Re: Stewart's Shops – Altamont
Further Review of Zoning Change of 107-109 Helderberg Ave.

**Analysis/Comments on the Proposed Rezoning of Parcel 48.06-2-2 from R10 to CBD
Submitted to the Village of Altamont Board by Nan Stolzenburg, AICP CEP**

Zoning Districts with Parcel 48.06-2-2 highlighted

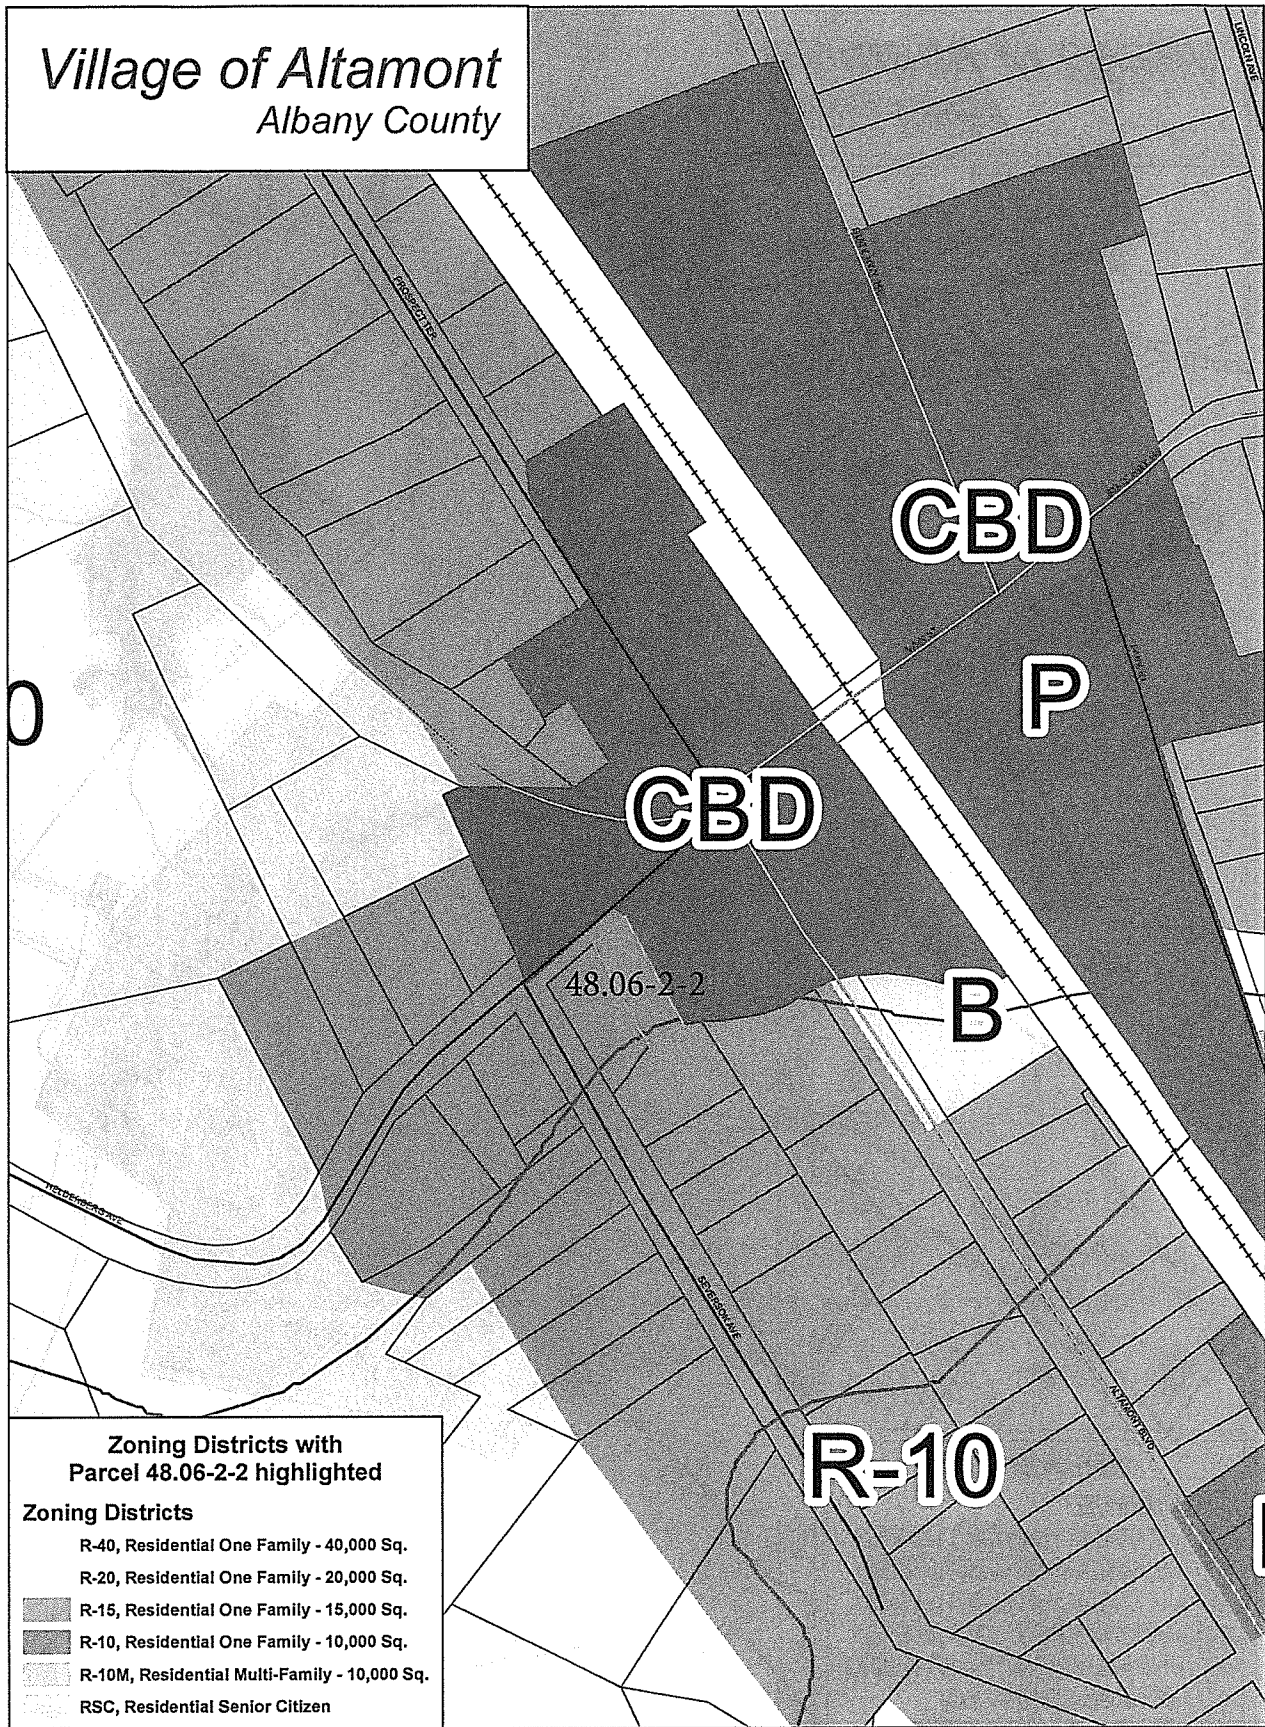
9. Removal of that residential parcel will leave a single remaining residential use on that block. I'm not sure how that would affect the community character of that street corner, or if that's a concern mentioned in the comp plan, or otherwise.

I have attached two maps showing the parcel in relation to the zoning districts for your information.
